PLANNING AND DEVELOPMENT SERVICES STAFF REPORT

For Planning Commission Meeting of January 21, 2015

**SUBJECT: Flagstar Bank Drive-Thru Special Exception Use and Site Plan for City Council Approval
(3600 Plymouth Road)
File Nos. SEU14-014 & SP14- 046**

DRAWING NUMBER:
C-2.1

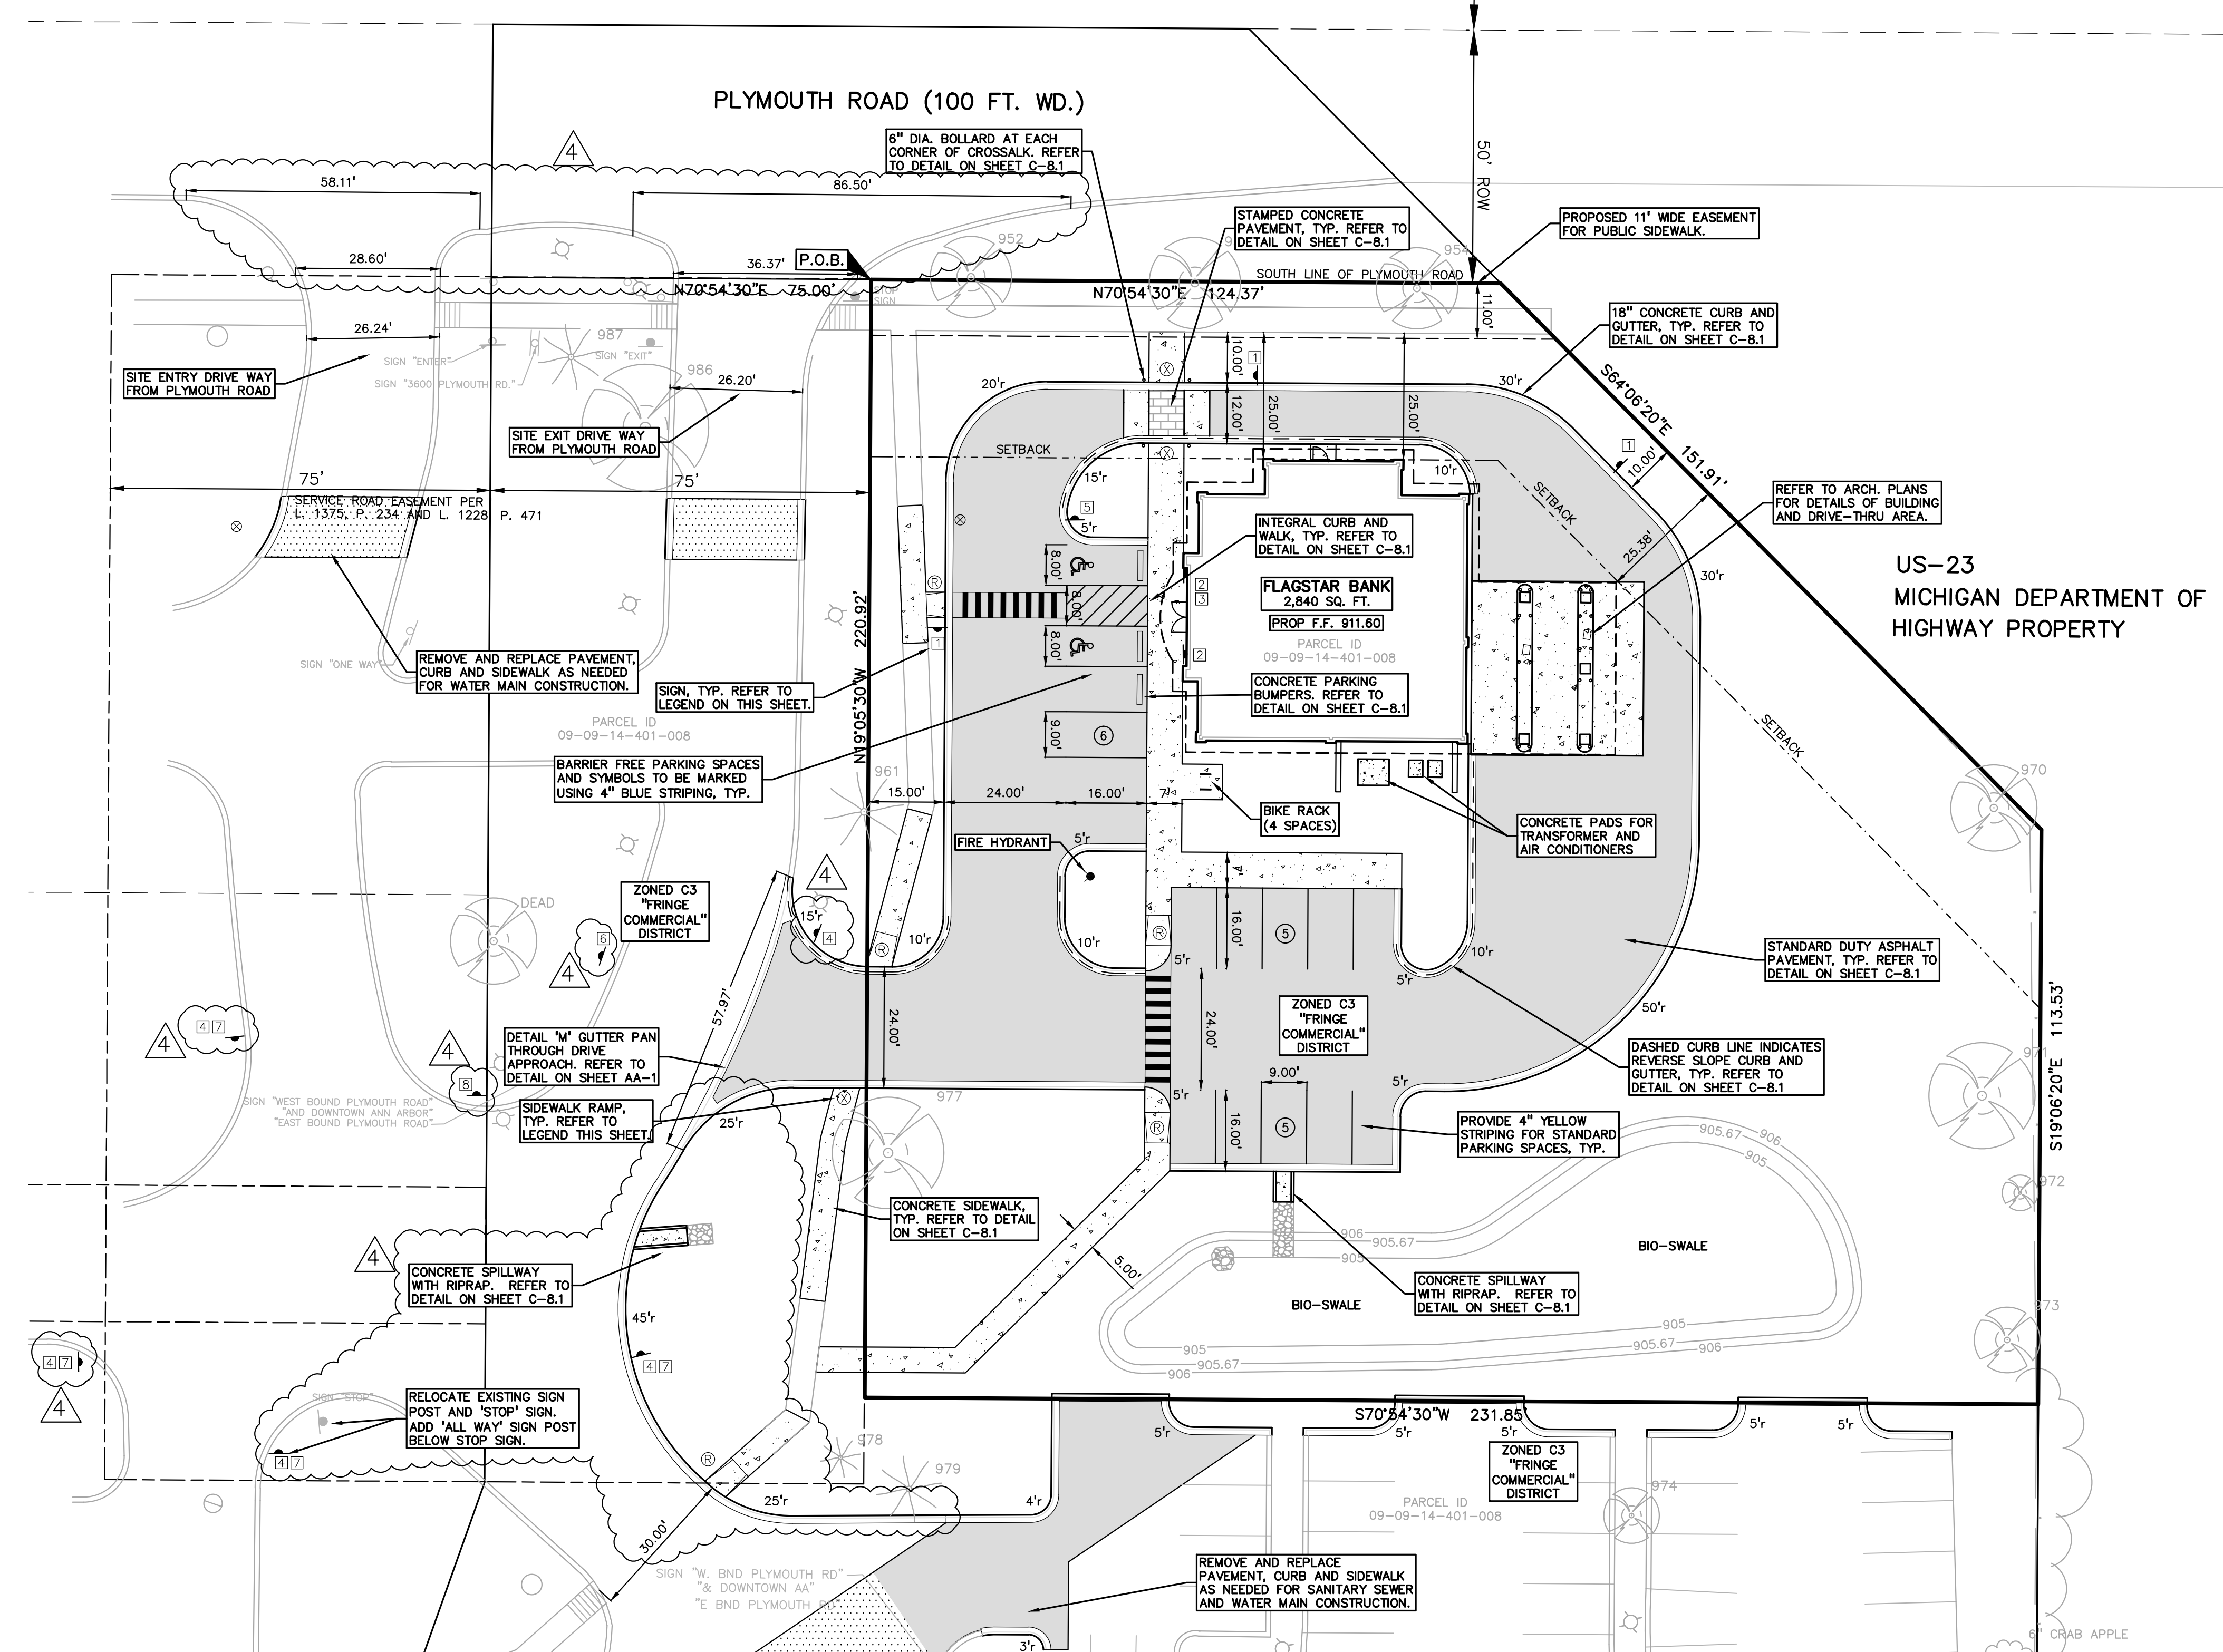
This petition was postponed on November 5, 2014, to allow the petitioner additional time to address traffic comments and City Planning Commission concerns. The petitioner submitted a revised site plan responding to the concerns raised at the meeting. The City Traffic Engineer has requested further revisions to the proposed drive entrance to reduce turning conflicts when exiting this site and to facilitate west bound travel onto Plymouth Road.

Revised Site Layout – The two internal parking lot connections between this site and the hotel site to the south have been removed, reducing impervious surface by approximately 4,040 sq ft for a new total of 18,569 sq ft. Two additional pedestrian connections are proposed, with one connecting to the hotel site and the other to the existing service drive sidewalk. Both pedestrian links lead to the western bank entrance.

Traffic Circulation – The proposed reconfiguration of the site's parking lot layout resulted in relocation of the entrance drive. The City Traffic Engineer requested the entrance drive be shifted further south to reduce turning conflicts as recommended in the Traffic Study Conclusion. It is anticipated this drive relocation will be submitted and reviewed by the City Traffic Engineer before the upcoming City Planning Commission Meeting.

5. The proposed site driveway should be located south of the two-way cross road in the median of the Plymouth Road driveway to reduce the frequency of blockage and improve site access.

The petitioner has agreed to install the recommended improvements and will be shown on the revised site plan.
